Re: Development R/64/17/PL PLANS.

Ref – Planning Application R/64/17/PL for Demolition of 1 No. dwelling & erection of 4 no. dwellings, at St. Mary's Close, Hurst Road, Rustington.

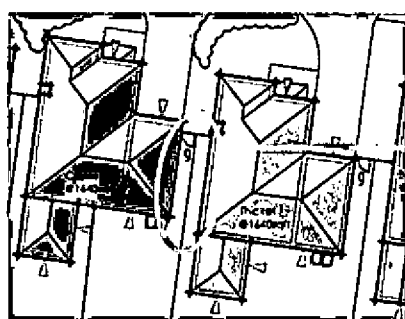
The detached garage blocks / car ports partially obstruct the view of the houses with Plot 4 having the appearance that it is accessed through the car port. This will completely ruin the street scene and fails to meet the criteria of the Local Plan D SP1 Design 13.2.2 which states *'the successful introduction of*

With regards Plot 4 – Sandbank, we were informed by the developer that there would be one window on the western elevation overlooking our property, Knowle. We note that the application now shows three windows.

Extract from Site Layout CSL-01

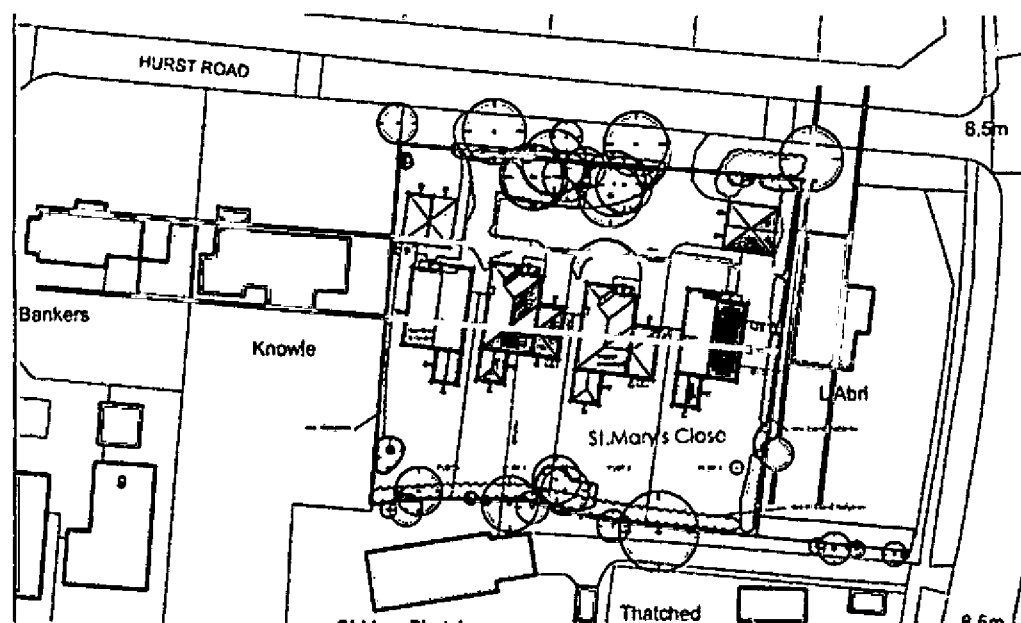
- There is a significant lack of dimensions leaving the development wide open to change if implemented;
- The architect has cleverly shaded out the rear portions of plots 2 and 3 to create an optical illusion of space between the properties;
- There appear to be several inconsistencies between the plans and elevations which again create the illusion of space. The following two extracts demonstrate how the spacing between plots 2 and 3 vary between the drawings, with the plan showing approx 2m and the elevation showing as little as 600mm between the eaves (measurements scaled as none provided on drawings);
